**ATTACHMENT 3
LICENSE AMENDMENT REQUEST
EXTENDED POWER UPRATE**

**RENEWED FACILITY OPERATING LICENSE
AND
TECHNICAL SPECIFICATIONS
MARKUPS AND CLEAN PAGES**

**FLORIDA POWER & LIGHT
ST. LUCIE UNIT 2**

**FIGURE 2.1-1: REACTOR CORE THERMAL MARGIN SAFETY LIMIT LINES
FOUR REACTOR COOLANT PUMPS OPERATING**

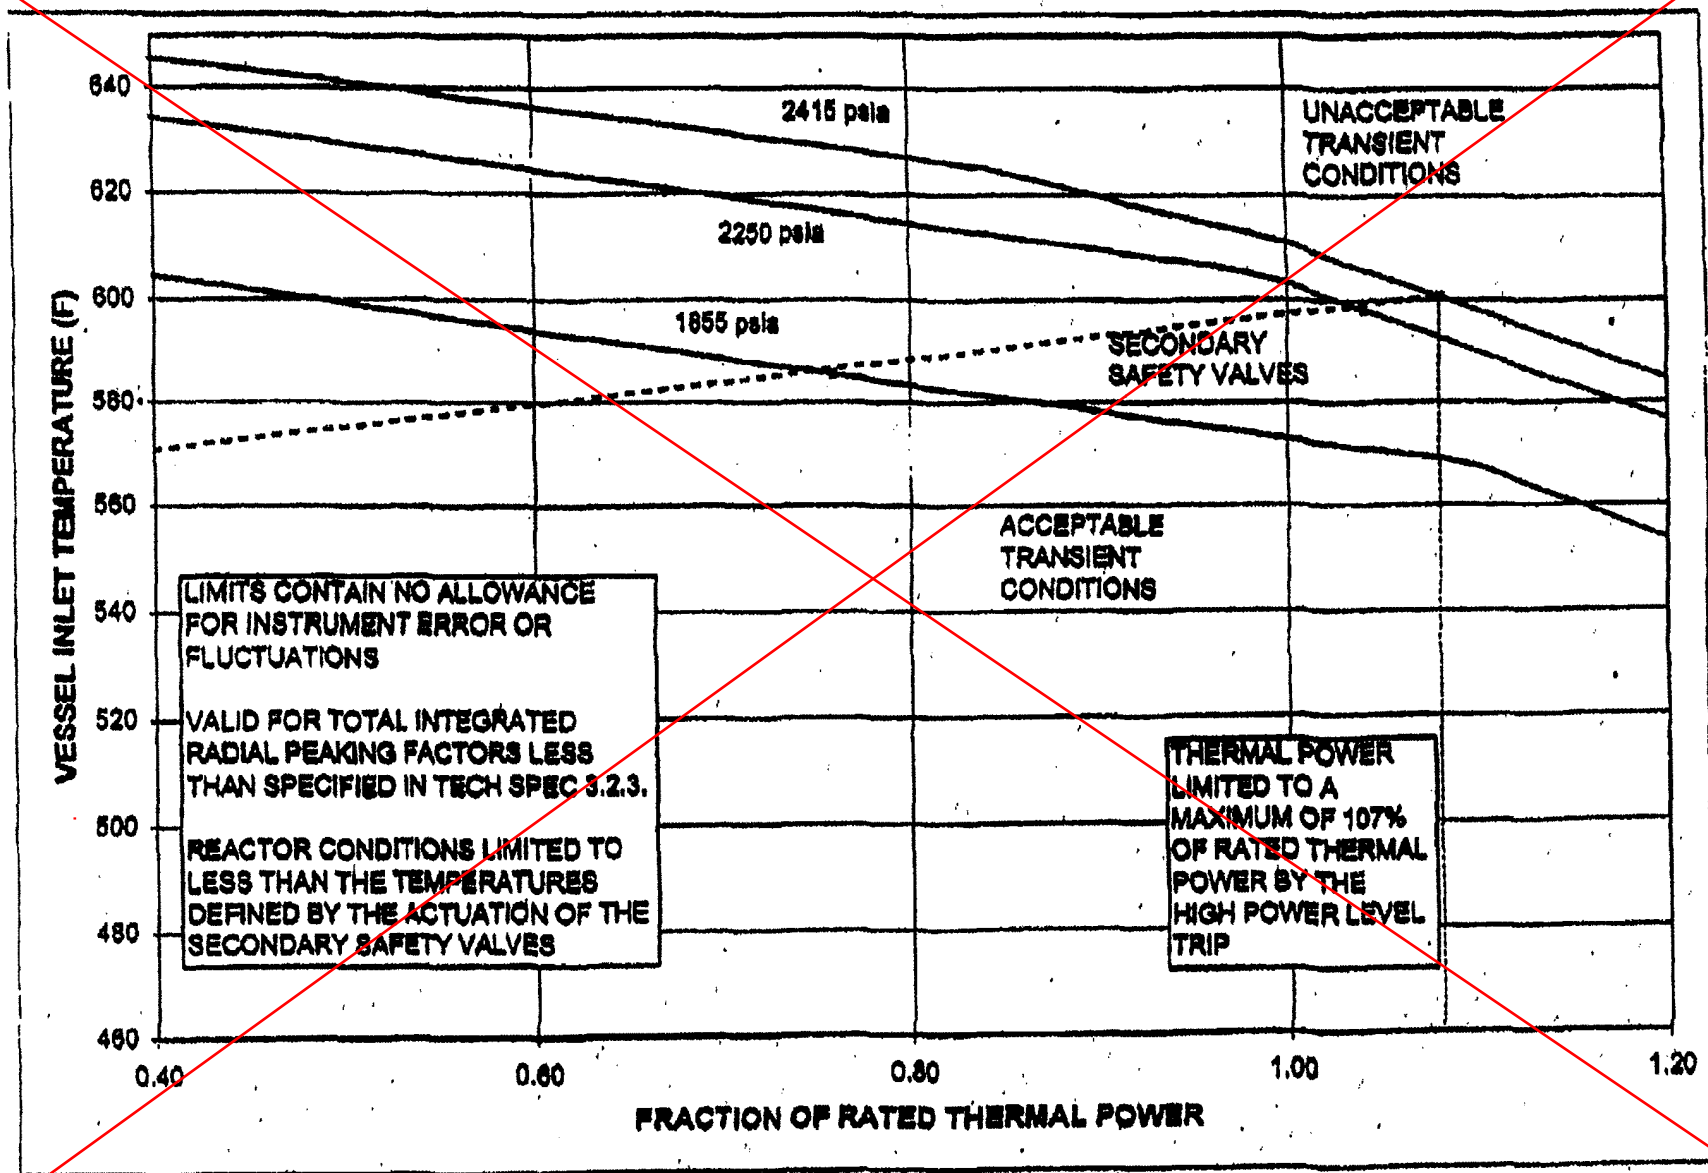
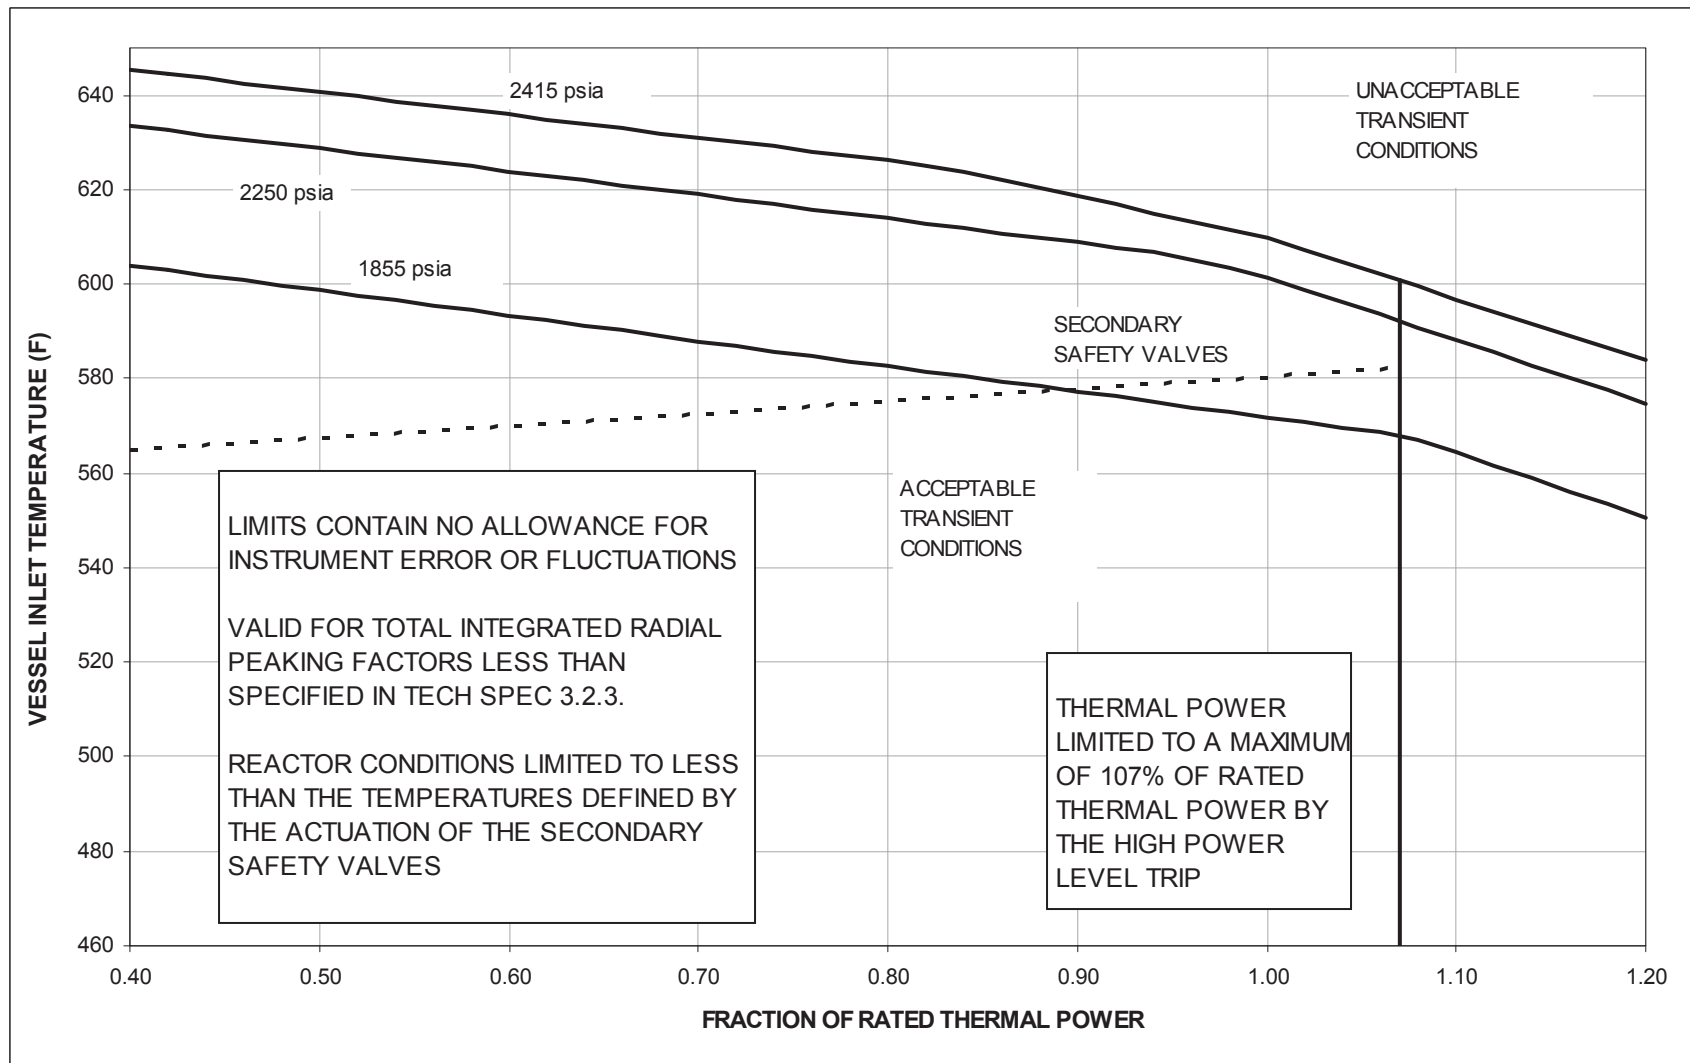
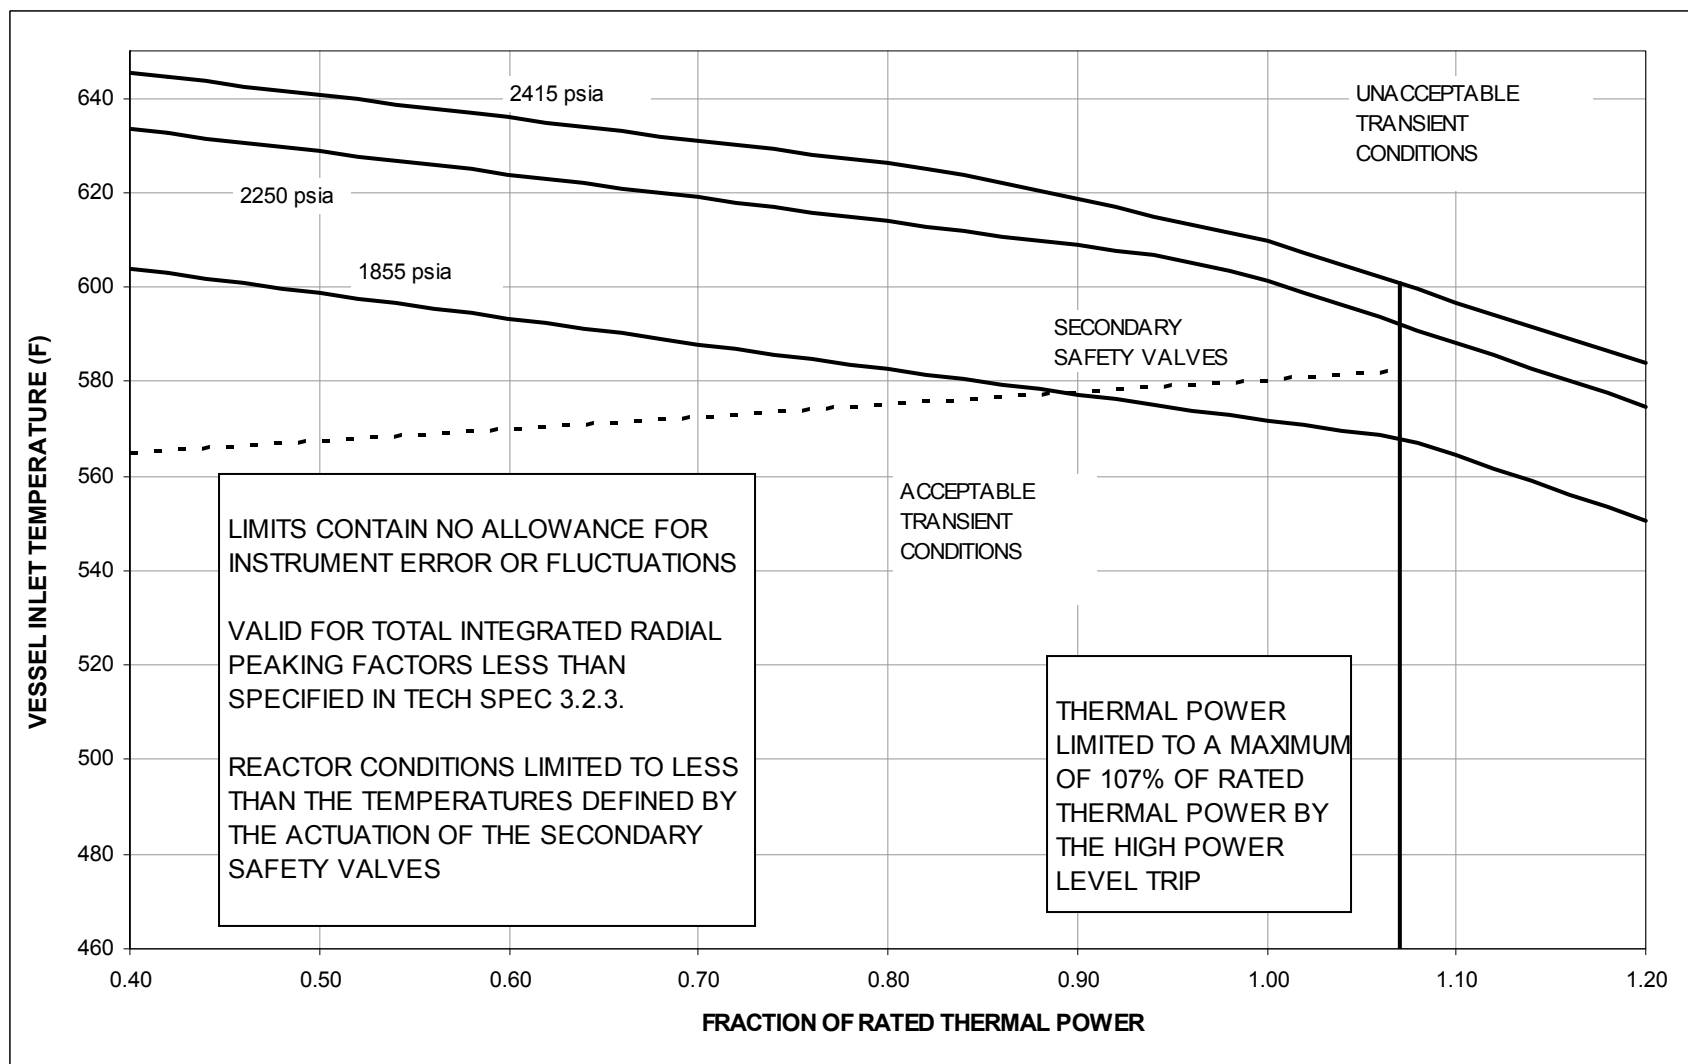
See INSERT 3 - New Figure 2.1-1

INSERT 3

**FIGURE 3.1-1
MINIMUM BAMT VOLUME vs STORED BORIC ACID
CONCENTRATION**

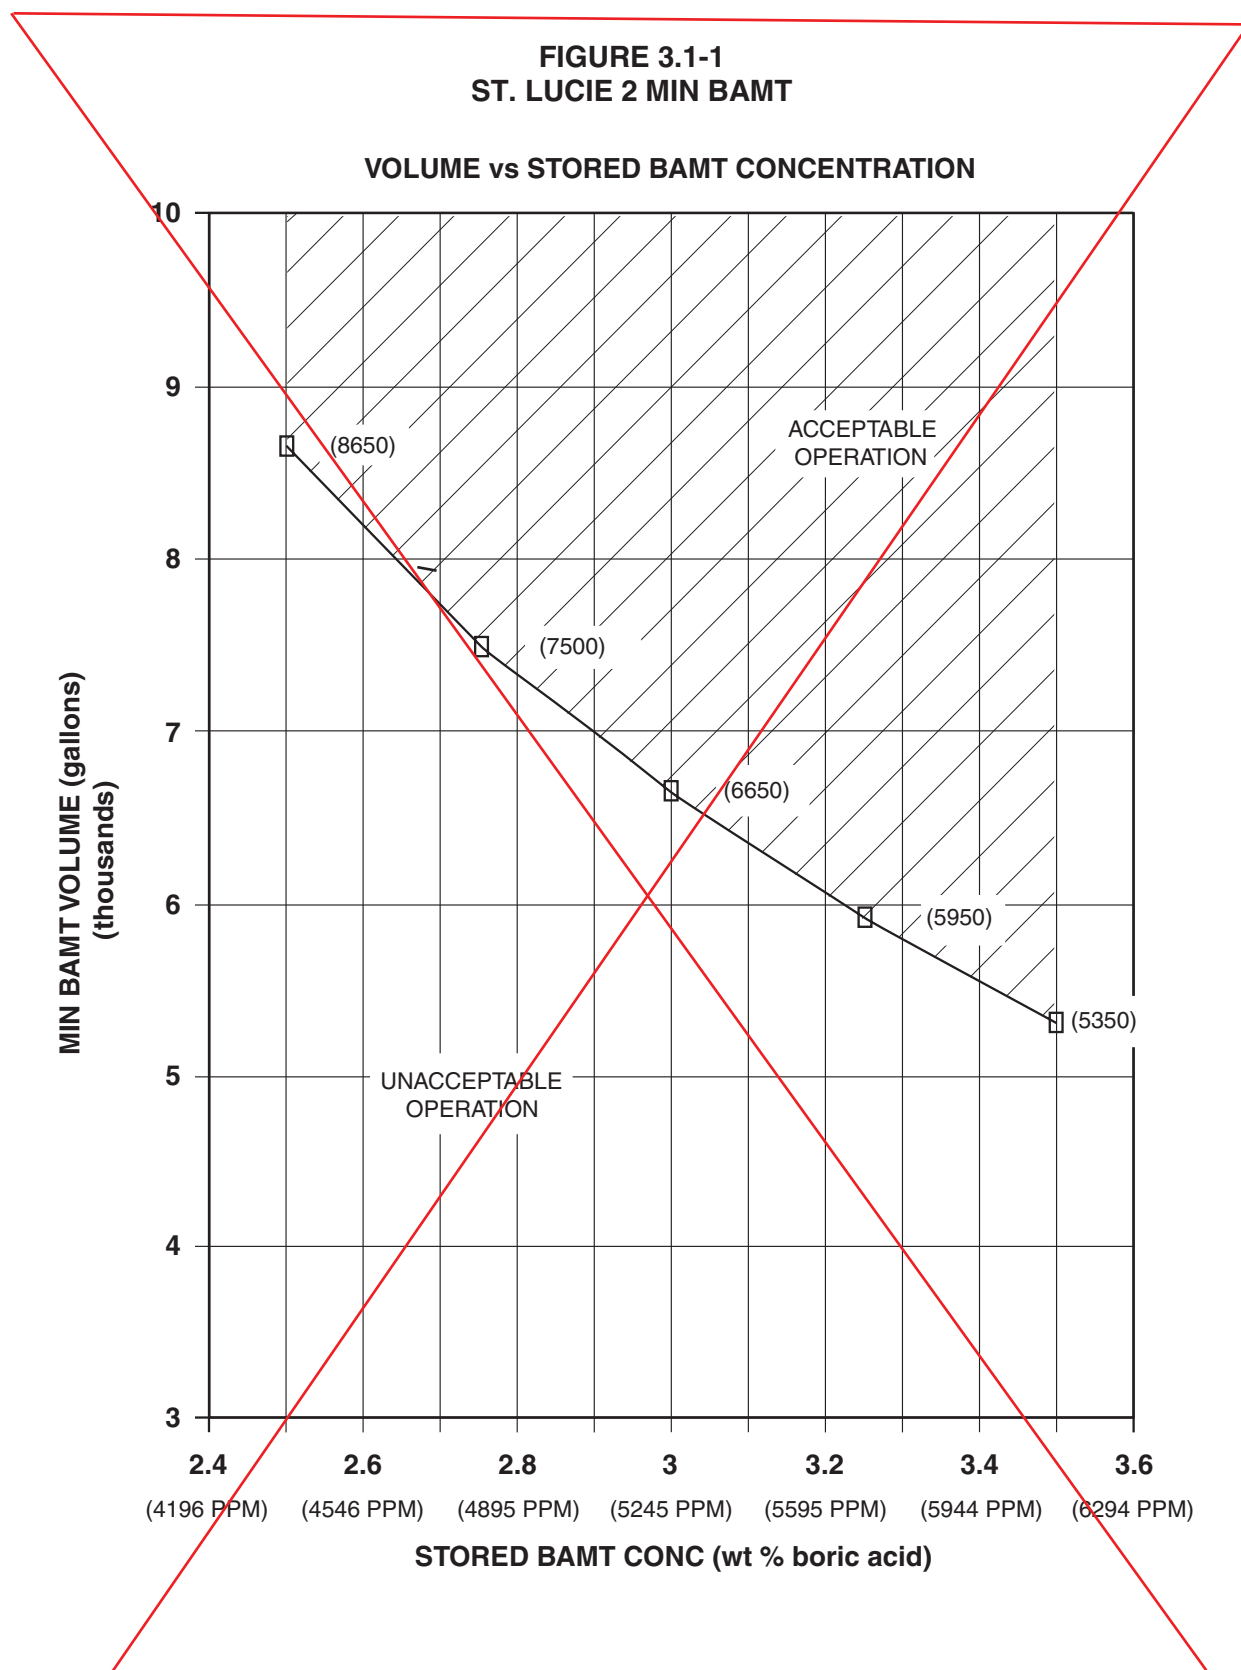
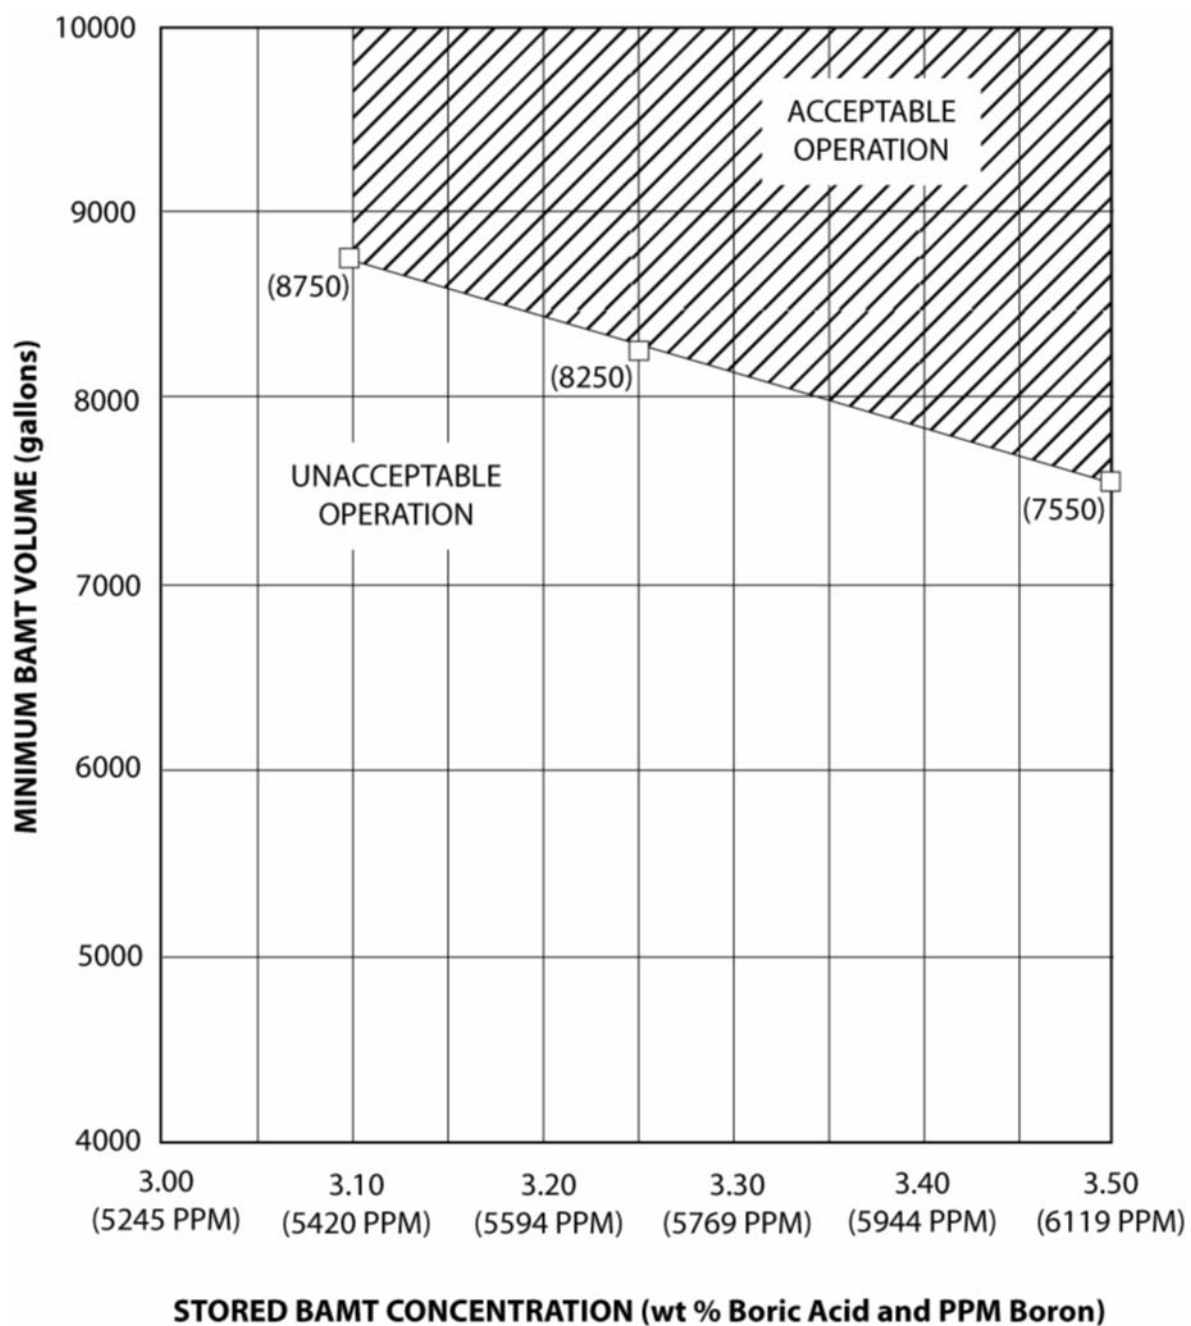
- a. Boric Acid Makeup Tank 2A in accordance with Figure 3.1-1.
- b. Boric Acid Makeup Tank 2B in accordance with Figure 3.1-1.
- c. Boric Acid Makeup Tanks 2A and 2B with a minimum combined contained borated water volume in accordance with Figure 3.1-1.
- d. The refueling water tank with:
 1. A minimum contained borated water volume of 477,360 gallons,
 2. A boron concentration of between ~~1720 and 2100~~ ppm of boron, and
 3. A solution temperature of between 55°F and 100°F.

- 3.1.2.8 At least two of the following four borated water sources shall be OPERABLE:
- a. Boric Acid Makeup Tank 2A in accordance with Figure 3.1-1.
 - b. Boric Acid Makeup Tank 2B in accordance with Figure 3.1-1.
 - c. Boric Acid Makeup Tanks 2A and 2B with a minimum combined contained borated water volume in accordance with Figure 3.1-1.
 - d. The refueling water tank with:
 1. A minimum contained borated water volume of 477,360 gallons,
 2. A boron concentration of between 1900 and 2200 ppm of boron, and
 3. A solution temperature of between 55°F and 100°F.

FIGURE 3.4-1

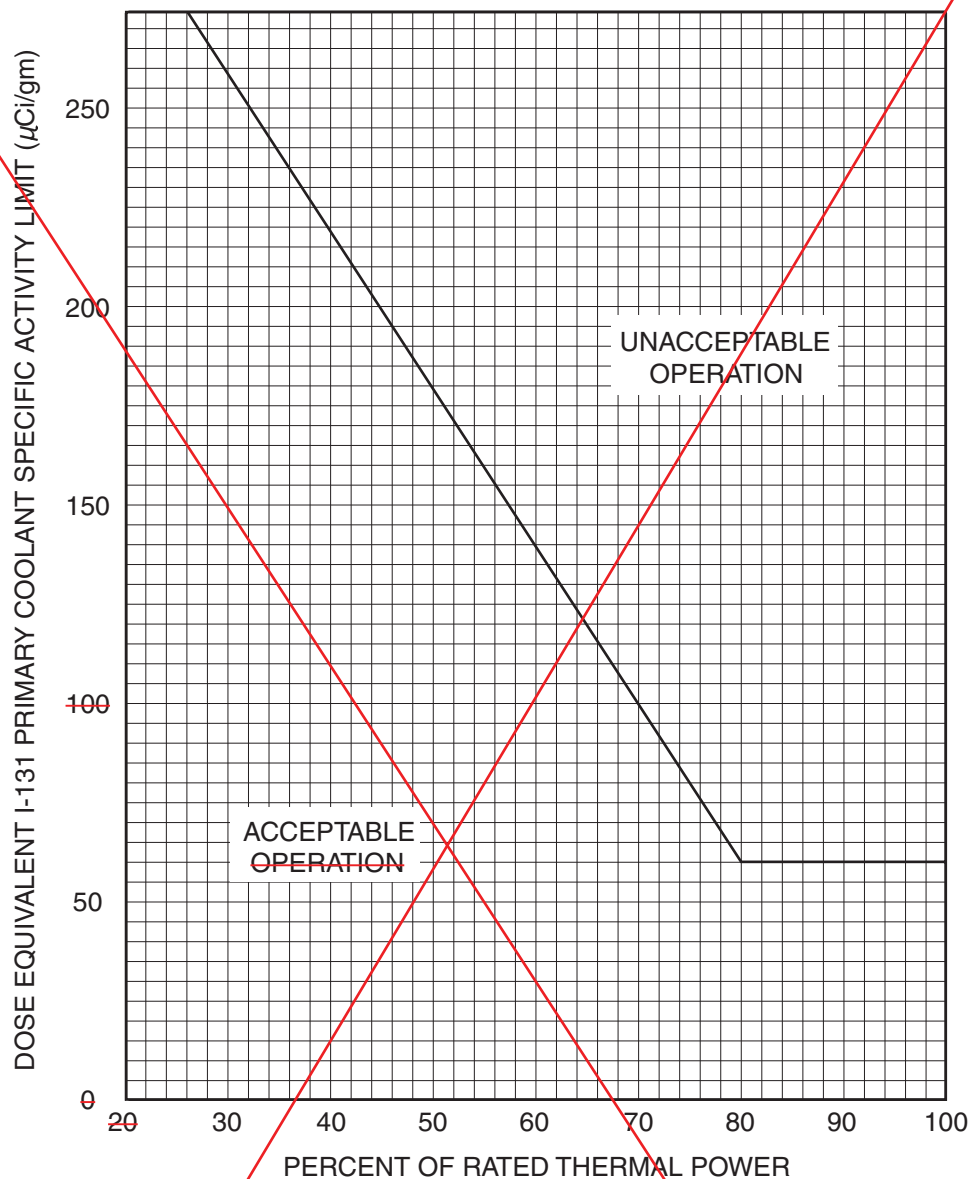
DELETED

DELETED
